Access Compliance Report

Public Rights-of-Way

Intersection ID: 2842	Main Street: BEAUVISTA_DR	Cross Street: ELM_COVE_LN	Location: NW
ADA ID: 37E569361C4C	Ramp Type: PerpDiag	Initial Pass/Fail: Fail	Overall Compliance: No
		Severity Score: 22.5

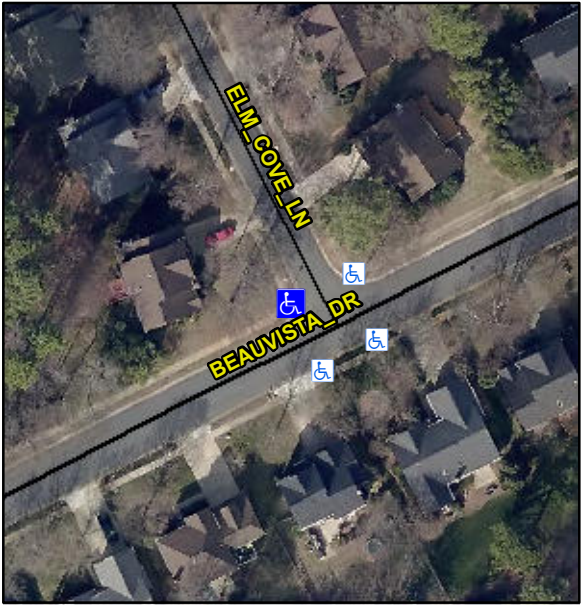
Codes/Mitigation Info/Possible Solution			Field Measurements/Component Compliance		
	Possible Solutions:		Compliance	Description	Data
	Remove & Replace Curb Ramp With Two New Directional Ramps or Equivalent.		No	Ramp Length (in)	48.5
			No	Ramp Width (in)	41.5
			N/A	Flare Type LT	N/A
			N/A	Flare Slope LT (%)	N/A
			N/A	Flare Traversable LT?	N/A
			N/A	Landing Length (in)	N/A
			N/A	Landing Width (in)	N/A
			N/A	Landing Slope (%)	N/A
			N/A	Landing X Slope (%)	N/A
			N/A	Landing Curb? (Y/N)	N/A
			N/A	Shared Landing?	N/A
			N/A	Gutter Ponding?	N/A
			N/A	Gutter Lip Ht (in)	N/A
			No	Painted X Walk1?	N/A
				X Walk 1 Direction	To S
			N/A	X Walk 1 Width (in)	N/A
				X Walk 1 Slope (%)	6.8
				X Walk 1 X Slope (%)	1.6
			N/A	Ramp inside XWalk1?	N/A
<p>Surveyor Notes:</p> <p>N/A</p> <p>PROW/ADA:</p> <p>Not Found, R304.5.1, R304.2.2, R304.5.3</p>			N/A	Flare Type RT	N/A
			N/A	Flare Slope RT (%)	N/A
			N/A	Flare Traversable RT?	N/A
